WORKSHOP AGENDA

Planning Commission

June 13, 2023 @ 5:30 PM

C0.2

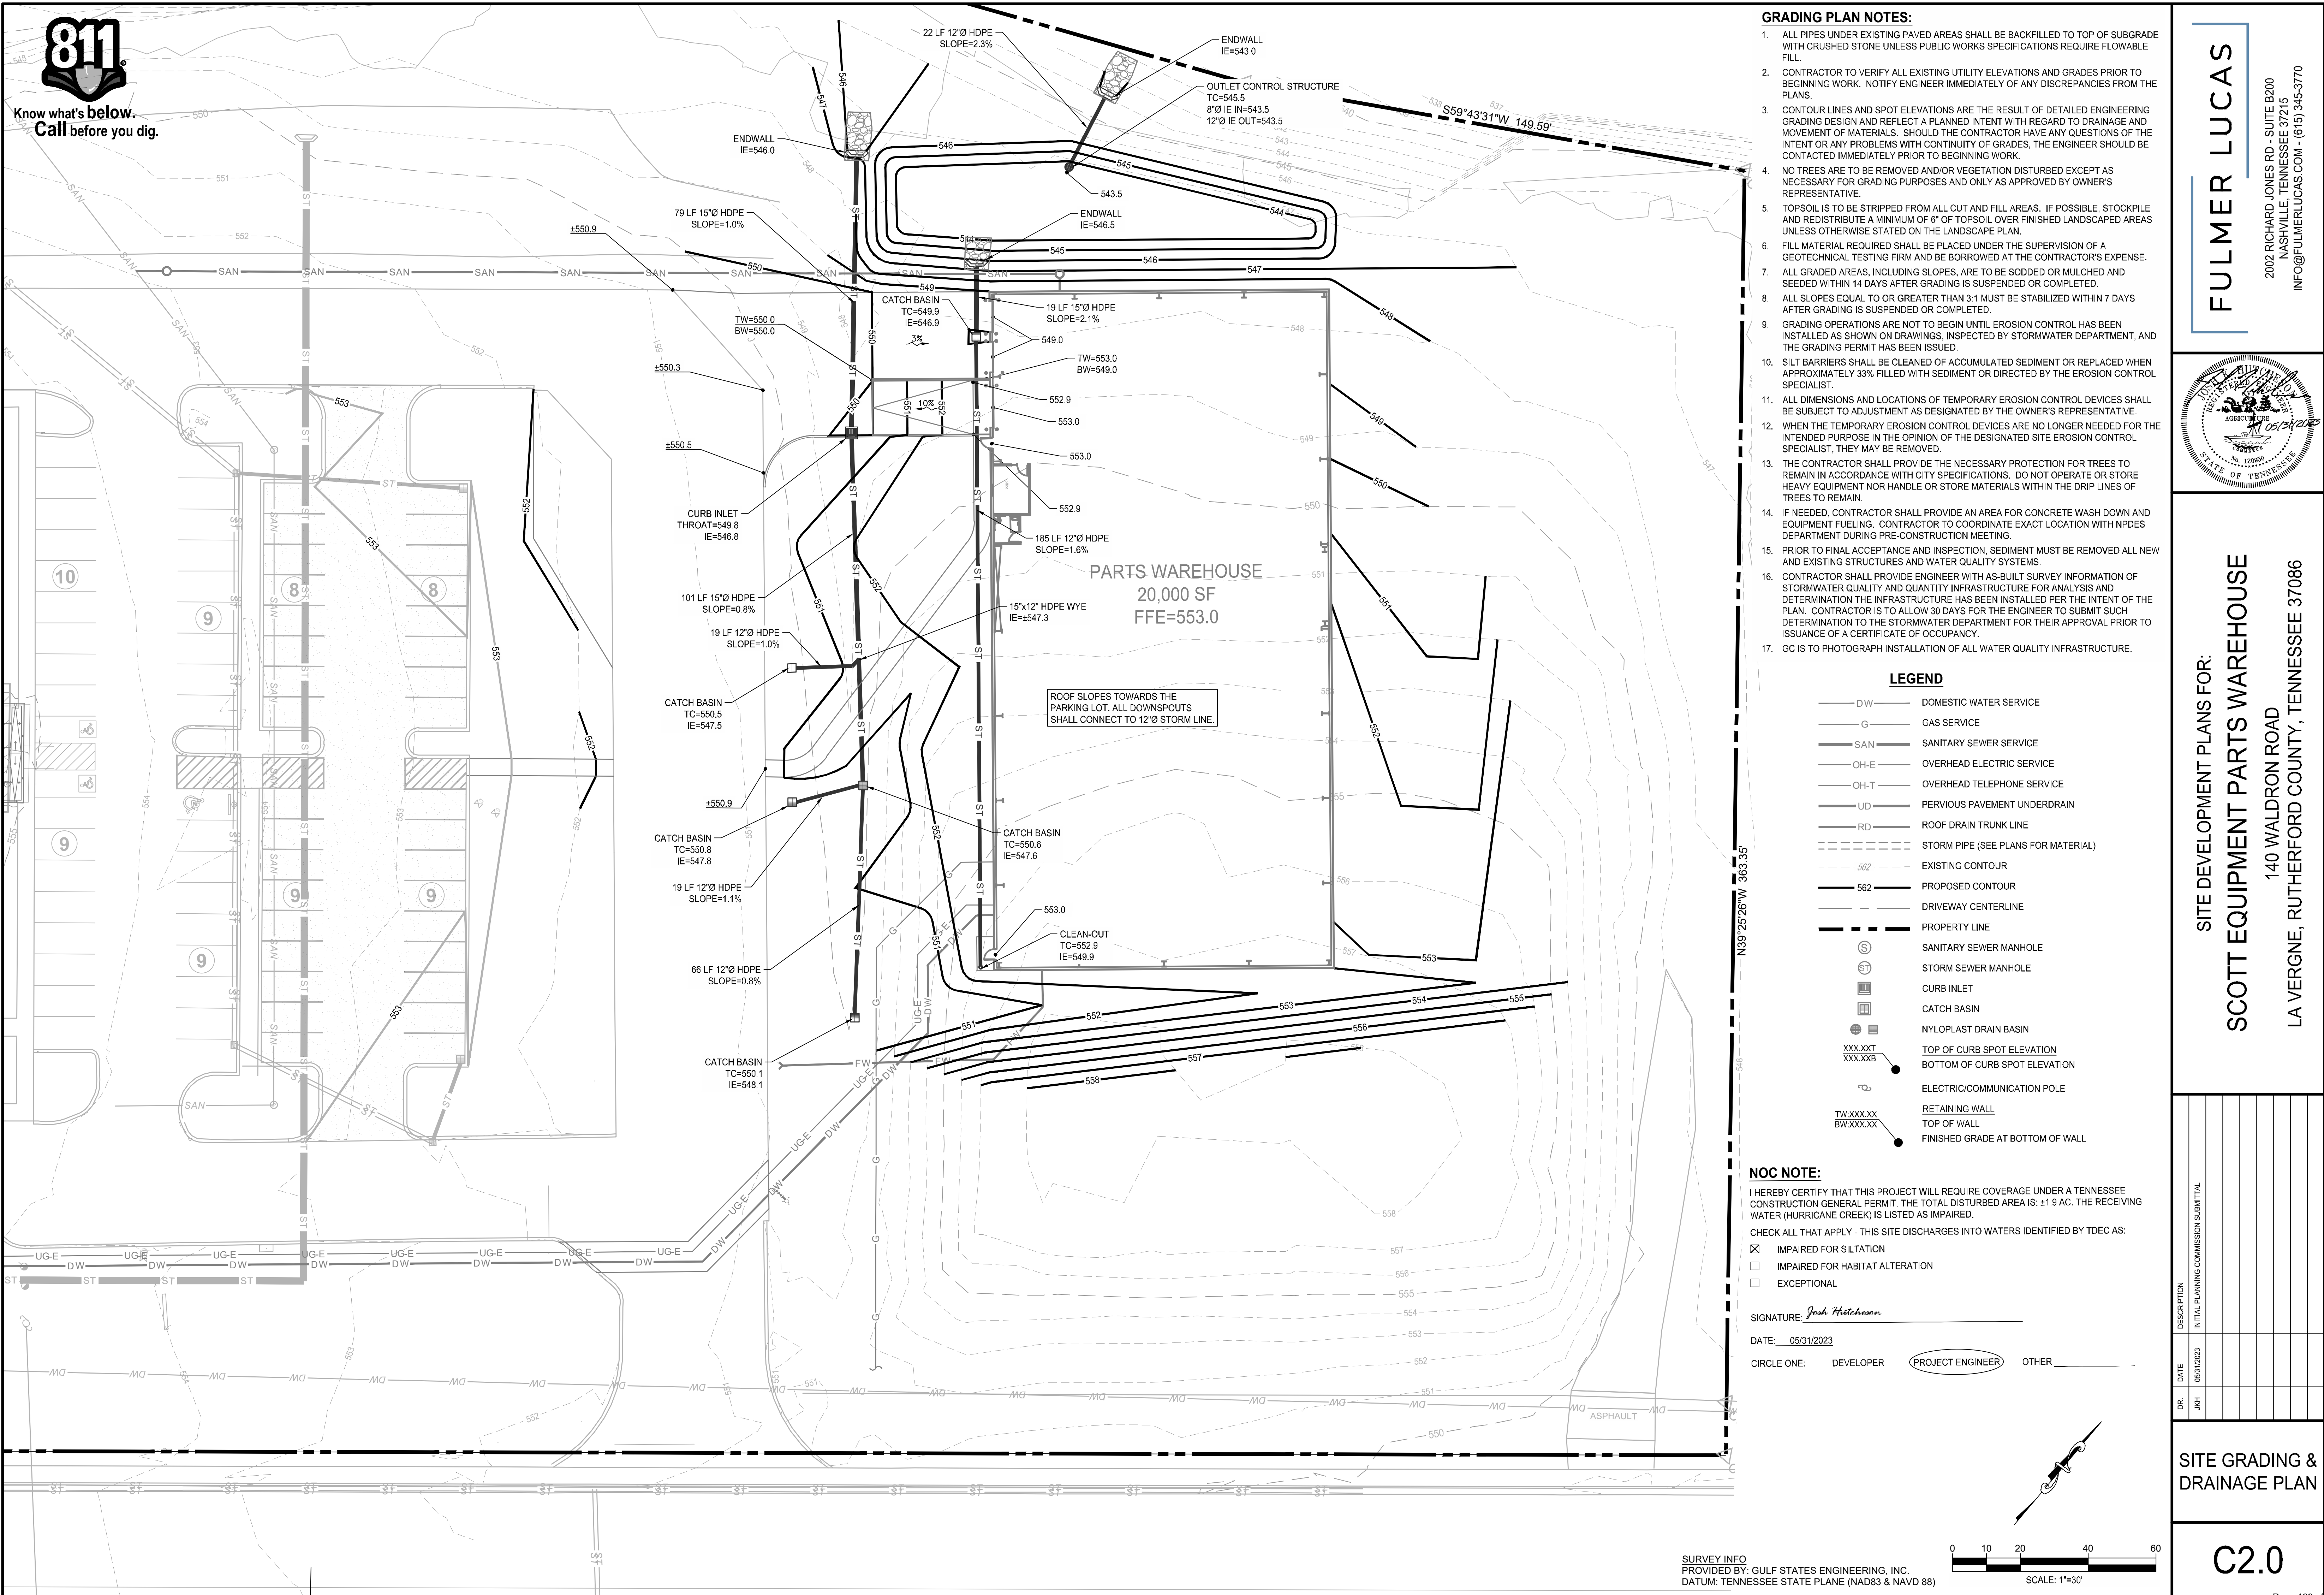
- appearance of the retaining walls proposed around Detention Pond #1.
2. Add a note on Sheet C0.2 that the mail kiosk will be installed, operational, and accessible via an all-weather asphalt surface prior to Certificates of Occupancy being issued on any lots in Section 1.
 3. Please provide dimensions and architectural information on monument sign located at Waldron Road.
 4. (Sheet C2.0) Subdivision Regulations require slopes of 12% to 20% and above 20% be shown. This sheet shows 15% to 20%. Please correct. Also, soil types must be shown for all slopes 12% or steeper.

C2.0

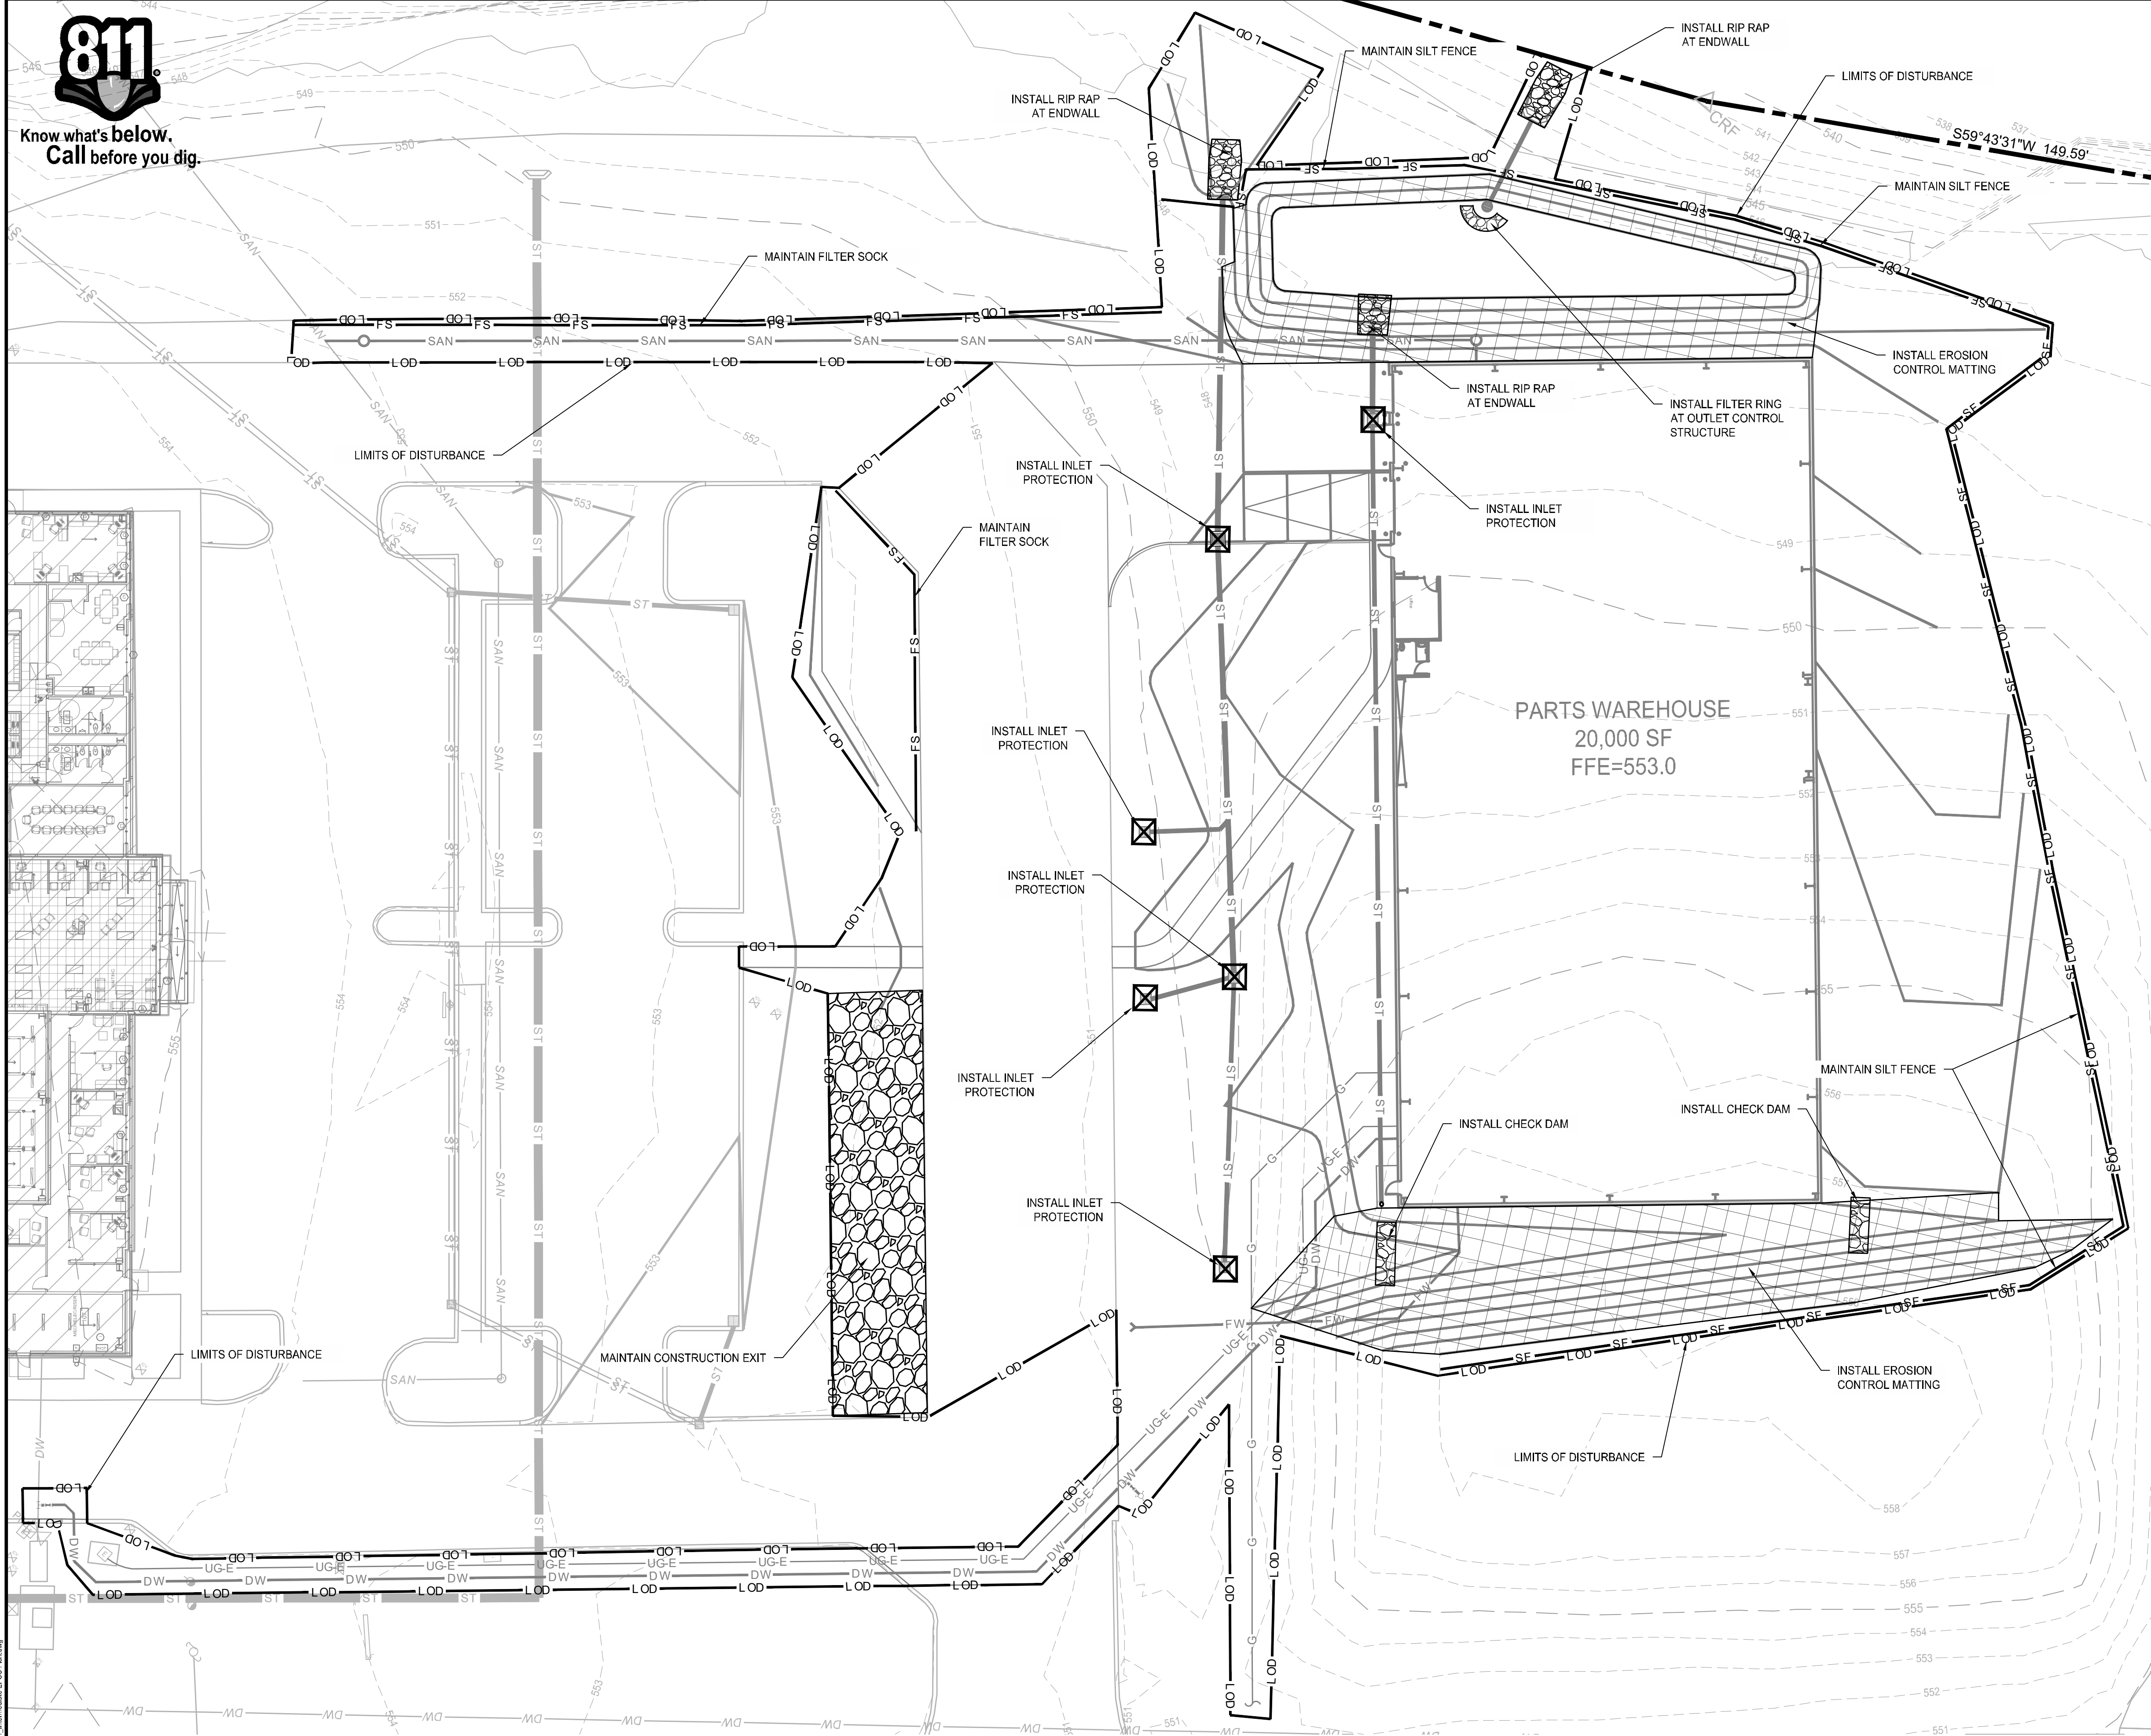
12. (Sheet C2.1) Provide silt fence or filter socks downstream of utility trench excavations.
 13. (Sheet C2.0) Change title of sheet to "Site Grading, Drainage, and Final EPSC Plan" to bring submittal into full compliance with City Ordinance Requirements. Also, show permanent groundcover on this sheet.

C2.1

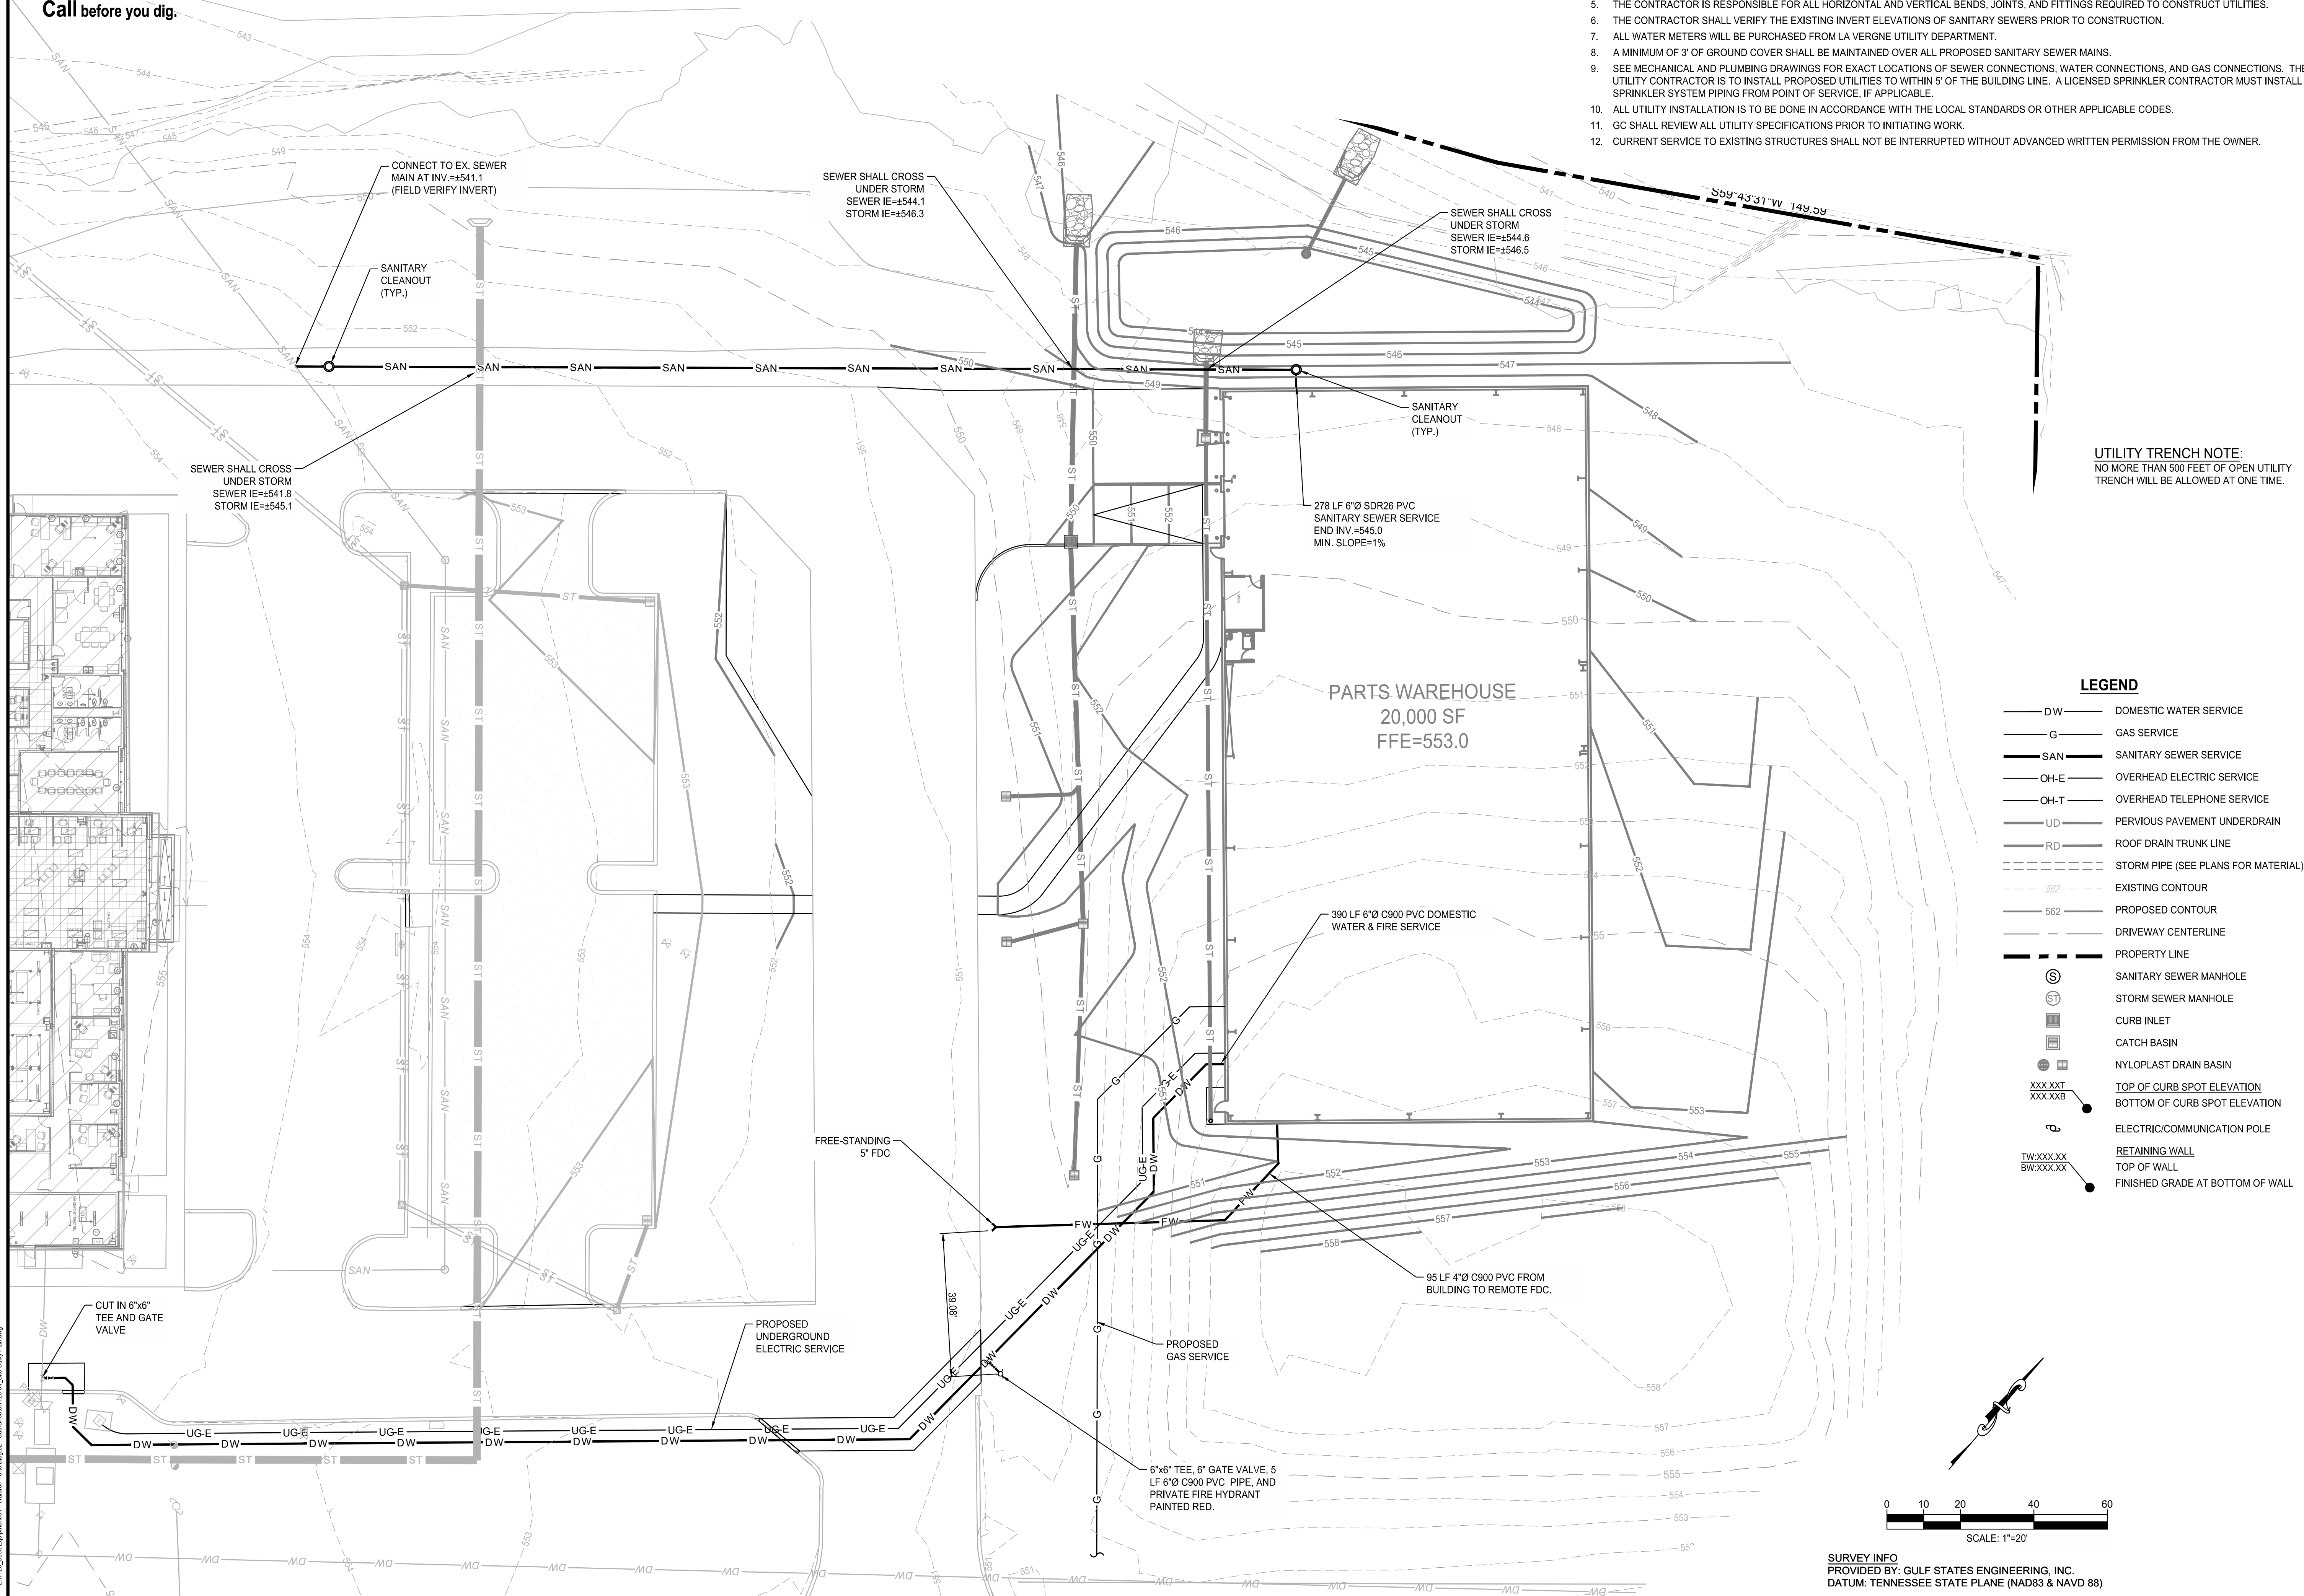
10. (Sheet C1.0) Provide details for the walk crossing of the drive which meet ADA standards.
 11. (Sheet C 0.2, C2.1, and C2.0) Show 'Stone Filter Ring' downstream from proposed pipe outfalls toward stream.
